CITY OF ST. LOUIS  
**PLANNING & URBAN  
 DESIGN AGENCY**

STRATEGIC LAND USE PLAN  
 AMENDMENT NO. 15/2016  
 Per 89.340 RSMo (2000) As Amended  
 CERTIFIED COPY

**Subject:** Amendment of the Strategic Land Use Plan (2005) of the St. Louis Comprehensive Plan  
*(Amendment #15 -- Lighthouse Saint Louis)*

To: Roman Kordal, Urban Planner  
From: William Kuehling *mk*  
Date: January 27, 2016  
Re: SLUP Amendment #15 Response to Comments

CHART\_126.pdf  
1083K

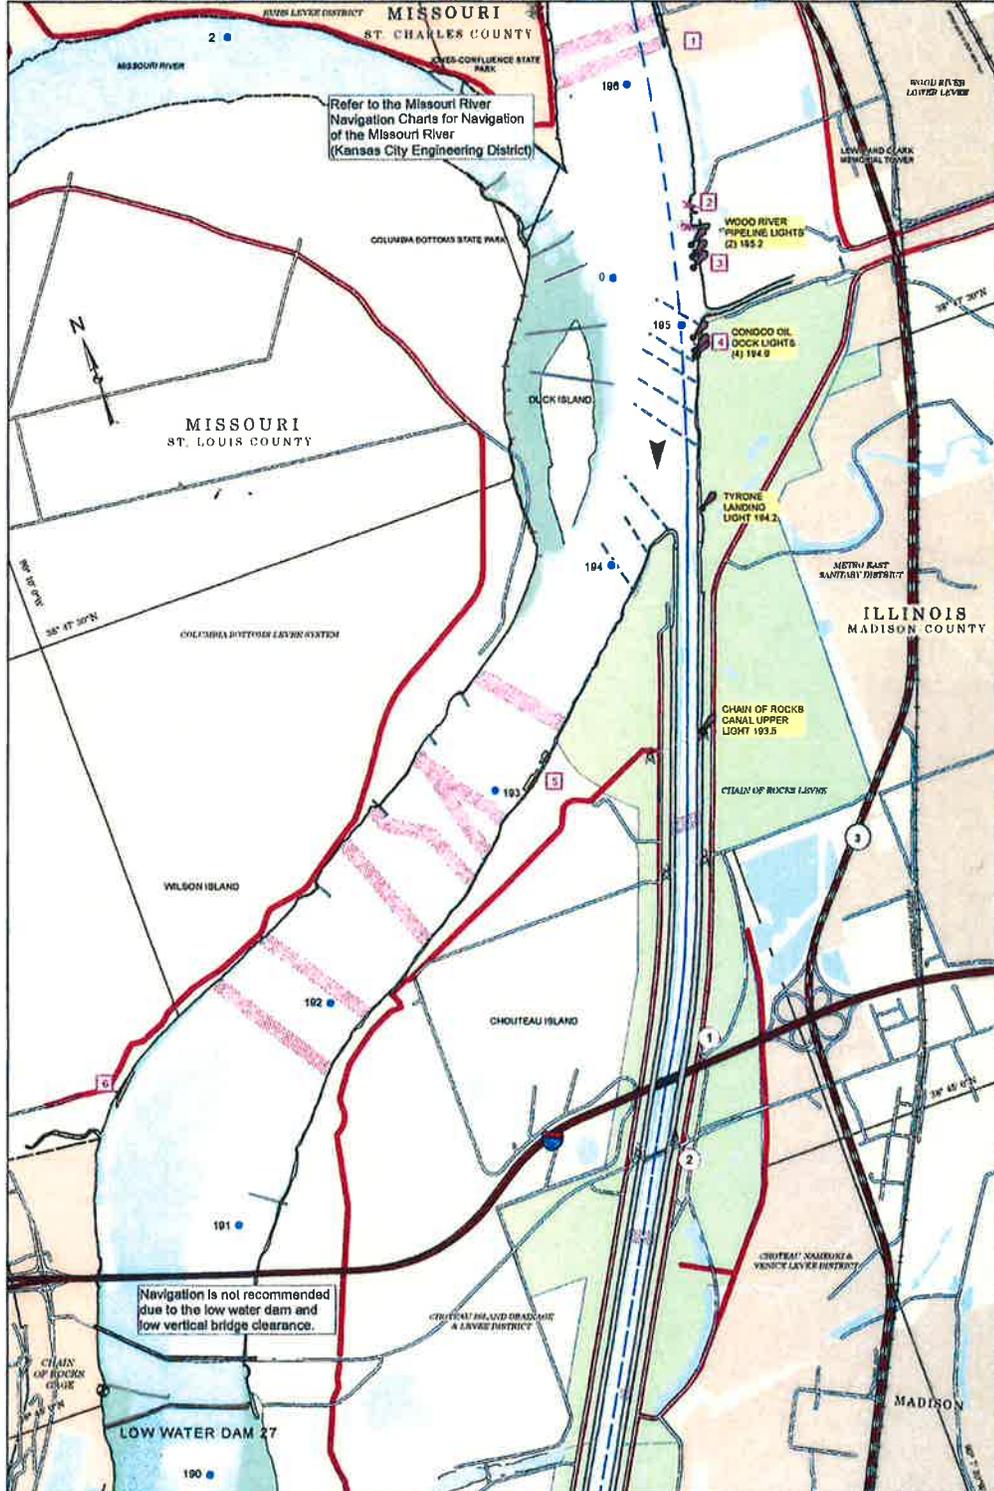
The Lighthouse plan includes a stone dike in the river. The Army Corps of Engineer's Upper Mississippi River Chart #26 (attached) doesn't show an existing dike. Has this been studied by a fluvial geomorphologist to determine what effect this river-training structure will have on river current? What is the potential for damage to the St. Louis city facilities down-river? After the recent floods, I wonder if this with this change in the direction of the river's flow, the nearby City of St. Louis's water treatment plant could be negatively impacted during high water or floods? Also, would the location of the dike contribute to the ongoing erosion at the former St. Louis construction landfill farther down river? If so, this could release lead, asbestos, and other toxic materials into the river. Either of these effects could be in direct conflict with the Sustainability Plan goal of providing clean drinking water.

"Ms. Reuter is correct that the stone dike that would be part of the proposed marina does not currently exist.

The Marina and attendant dike are planned to be part of phase 2 of the project.

Developers of the site have had preliminary discussions with the U. S. Army Corps of Engineers regarding the proposed marina, and it is anticipated that a structure of this type will be required. However in these preliminary discussions the Corps of Engineers have been very encouraging of the idea

Prior to the construction of any structure in the river, Corps of Engineers approval is of course necessary. As part of that approval process the Corps will require detailed plans and studies that will look at the implications of such a structure on the river itself and on other river users, including the City of St. Louis Water Division. These detailed studies will be done as part of phase 2 of the project.

It should be noted that the developers have also presented the concept of the marina to various City officials, including the head of the Water Division and no one has expressed any concerns regarding the effect of the marina on the water intake at the Chain of Rocks water treatment plant, or any other concerns regarding impacts on other users. It is important to remember that that the Chain of Rocks treatment plant is not only protected by the Chain of Rocks themselves, but by a cofferdam at the location.
